Project: Remediation  
Contractor: \_\_\_\_\_  
Address: 1411 S. Portman #100  
RSN: 27411  
Permit Number: 196750  
Date: AUG 2 4 2007

# Cabinet Replacement at Aurora Dialysis

at  
1411 South Potomac Street, Suite 100  
Aurora, Colorado 80012

CITY OF AURORA  
BUILDING DIVISION  
APPROVED AS NOTED  
DATE: *AUG 24 2007*  
*07 196750*

SHEET NO.  
**E3**

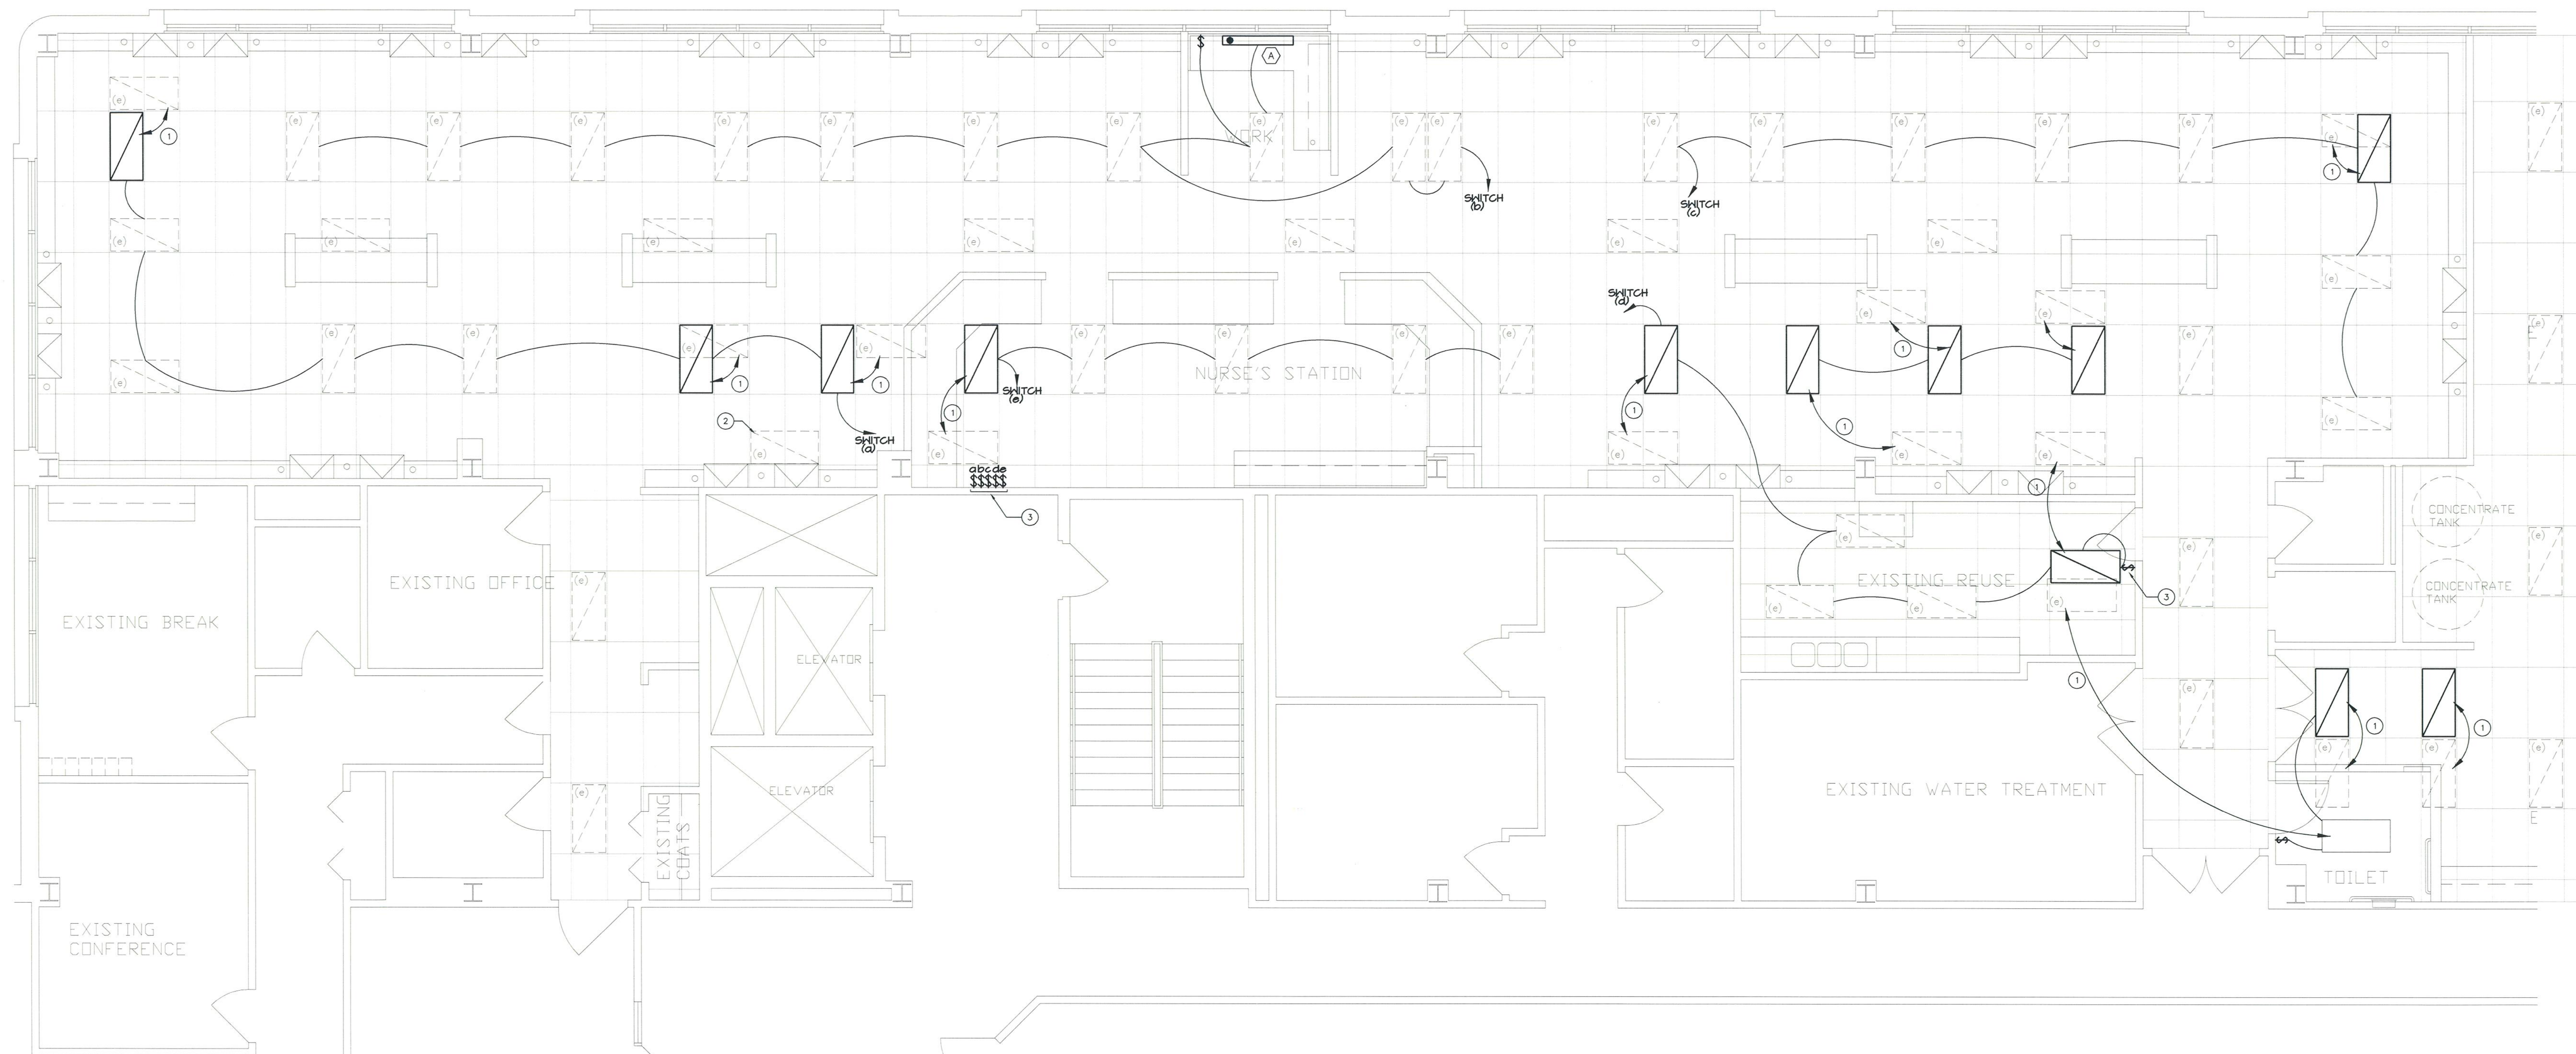
THIS SHEET OF DRAWINGS  
HAS NOT BEEN REVIEWED  
FOR CODE COMPLIANCE.
